STATE OF WASHINGTON
DEPARTMENT OF ECOLOGY

Re: Comments on First and Second Quarter Groundwater Reports, Request for Work Plan, and Resolution of Informal Dispute

- **Site Name:** Taylor Way and Alexander Avenue Fill Area (TWAIFA)
- **Site Address:** 1500 Block Taylor Way E, Tacoma, Pierce County, WA 98409
- **Agreed Order:** DE 14260
- **Enforcement Order:** DE 19410
- **Facility/Site ID:** 1403183
- **Cleanup Site ID:** 4692

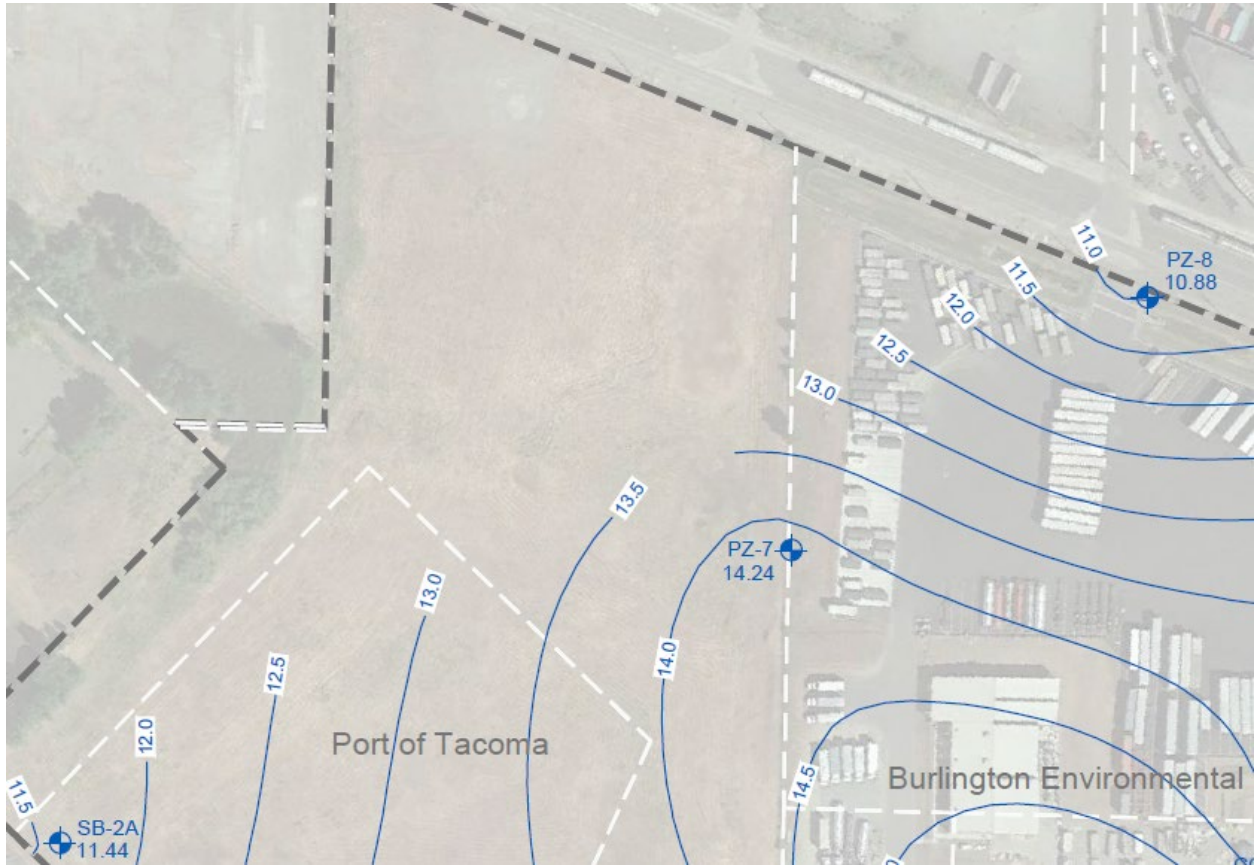
1. **Need for additional shallow aquifer monitoring wells:** Review of shallow aquifer groundwater analytical results and groundwater elevation data from the reports shows that the extent of the shallow aquifer contamination plume above data gap work plan screening levels is not completely defined. **Therefore, additional shallow aquifer groundwater monitoring wells need to be installed in the following areas (exceedance constituents shown in parentheses):**
 - a. Southeast of **CTMW-20** (total petroleum hydrocarbons, diesel range organics, TPH-D; TPH oil range organics, TPH-O; and manganese), **CCW-8B** (TPH-D; TPH-O; 1-

methylnaphthalene; and manganese), and **CCW-1A** (tetrachloroethylene, PCE; trichloroethylene, TCE; vinyl chloride [VC]; and manganese) and **CCW-1B** (copper and manganese). Also, it appears that the TPH contamination above MTCA Method A Cleanup Levels for Ground Water that have been observed in Emerald Services wells MW-3R and MW-4 are originating from the TWAFA Site.

- b. East of **CCW-7B** (TPH gasoline range organics, TPH-G; TPH-D; TPH-O; 1,4-dichlorobenzene; benzene; VC; 1-methylnaphthalene; and manganese).
 - c. North-northeast of **TWA-1** (TPH-D; TPH-O; VC; benzene; and manganese), **TWA-2** (TPH-D + TPH-O; arsenic; copper; and manganese), and **TWA-3** (arsenic; copper; and manganese).

- d. North and northwest of **CCW-3A** (TPH-D; TPH-O; benzene; arsenic; nickel; and zinc) and **CCW-3B** (TPH-G; TPH-D; TPH-O; benzene; VC; 1-methylnaphthalene; and manganese).

- e. Halfway between **CTMW-15** and **CTMW-20**. An additional well is needed here to define groundwater concentrations of chlorinated volatile organic compounds (cVOCs), including PCE, TCE, and VC due to elevated sub-slab vapor concentrations detected beneath the Shop Building on the Former Potter Property (Port of Tacoma, 2022). Soil samples shall be collected during well installation to determine if soil contamination is affecting groundwater in this area.

- f. Southwest of **SB-1A** (copper and manganese), **SB-2A** (manganese), and **CTMW-14** (copper).
 - g. Existing wells that are currently not part of the groundwater monitoring network should be evaluated to see if they can be utilized to partially meet this need in selected areas (for example Emerald Services wells MW-1, MW-2R, MW-3R, and MW-4; and Burlington Environmental wells PZ-7, PZ-8, and PZ-9). For more information on the Emerald Services well network, see Trihydro (2022).⁴

(From Figure 3, 1st quarter 2022 groundwater monitoring report)

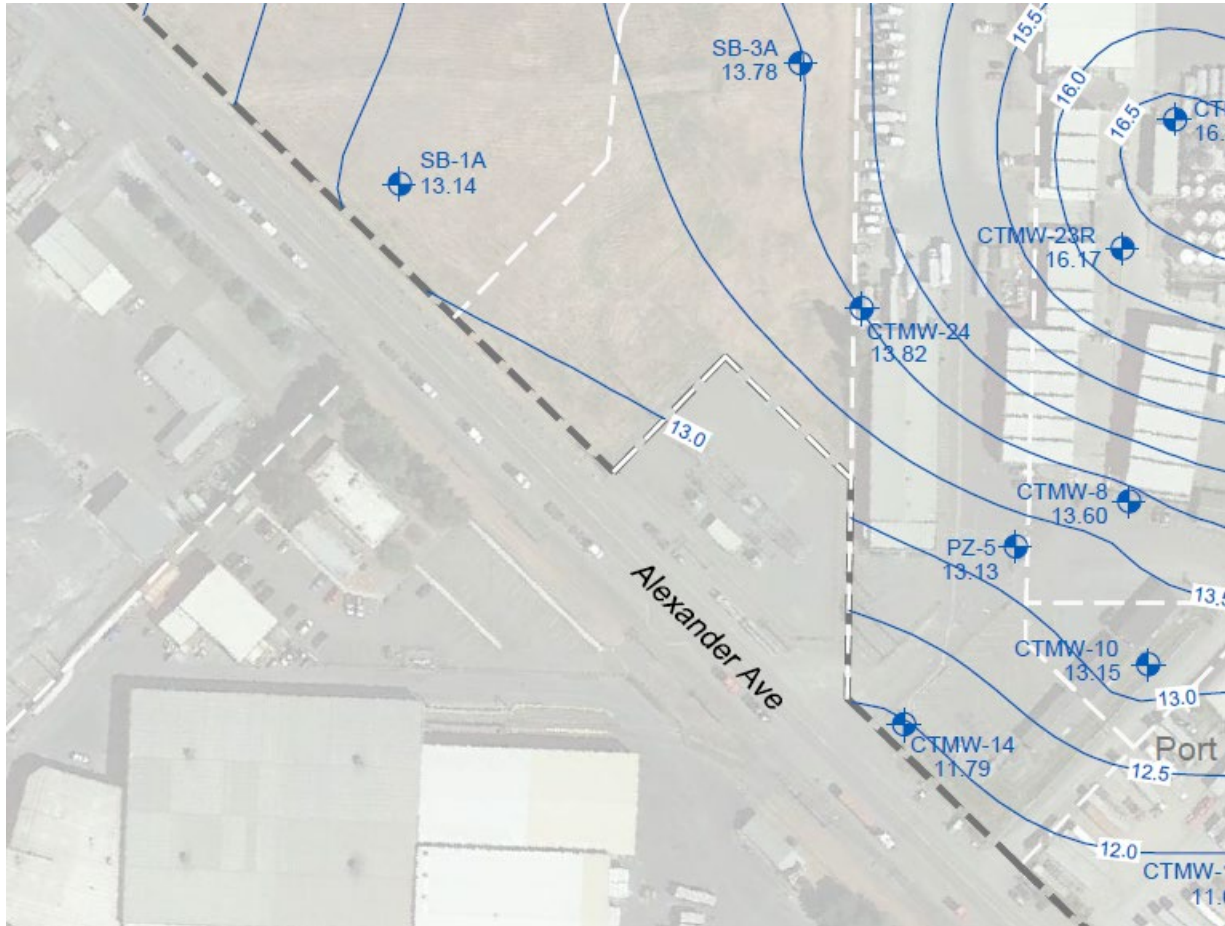
3. Groundwater elevation contour lines on figures should not stop at a parcel boundary, but should be connected with a solid or dashed line when possible. Please ensure that this is done on future report figures. Examples where contour lines should have been connected are shown below:

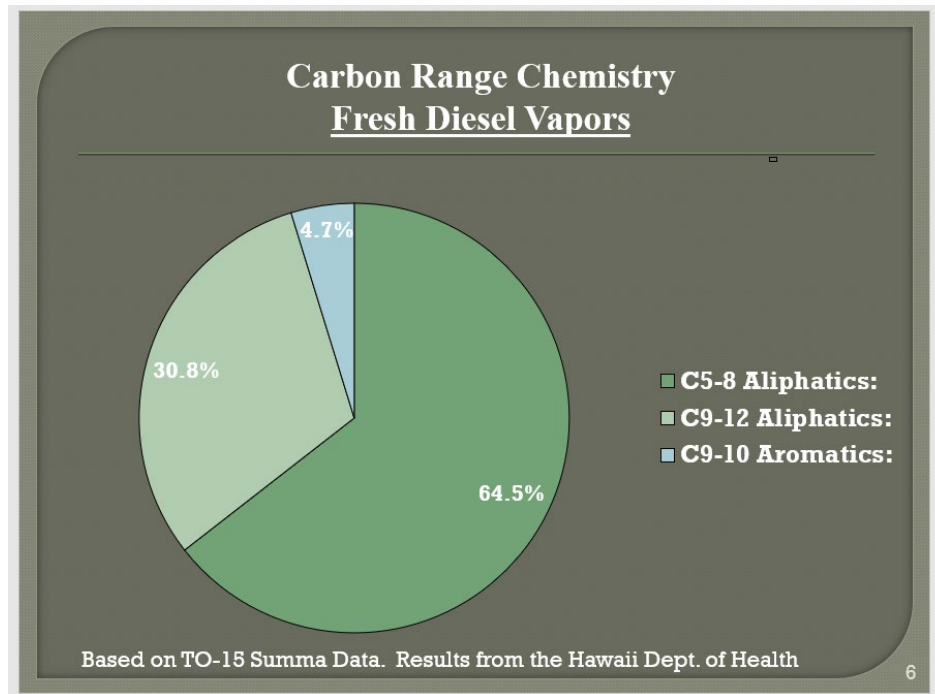
- *Port comment #1, Additional indoor air characterization – former Potter Property: Maul Foster (Port's consultant) is already under contract to prepare an Ecology-review draft workplan for the Potter Property, as Maul Foster recommended in the 10/6/2022 Vapor Intrusion Assessment Report. The Port can agree to install additional vapor probes. The Port would like to better understand the emphasis on the TPH, PCE and TCE in shop building location TWA-SV-41. The Port can install a probe in the shop building closer to the property line with Emerald Services. The Port expected more emphasis on the findings at TWA-SV-35 (coinciding with the historical presence of non-aqueous phase liquid) where concentrations of petroleum beneath the floor slab exceed screening levels by more than an order-of-magnitude above screening level exceedances at TWA-SV-41.*

Ecology response: Ecology has not received the above-referenced 10/6/2022 Vapor Intrusion Assessment Report. The extent of contamination at Quonset Hut 2 location TWA-SV-35 will need to be defined before the RI can be considered complete. However, the primary goal of this current workplan is to evaluate vapor intrusion risk potential. The indoor air samples that the Port is planning to collect within the buildings will help inform that risk. The results of the Quonset Hut 2 indoor air samples should be used to help determine if additional actions and/or sampling need to occur at -SV-35 in the near term or if this can be done later (as part of any other RI data gap work).

Based on the percentages of fractions, the source of the TPH may be fresh diesel, possibly from a release in the vadose zone (see below figure).

Location -SV-41 is of concern because of the proximity of the adjacent Emerald Services building and the uncertainty if TPH and/or PCE/TCE soil vapor concentrations from the TWAAFA Site have the potential to exceed sub-slab screening levels beneath that building.
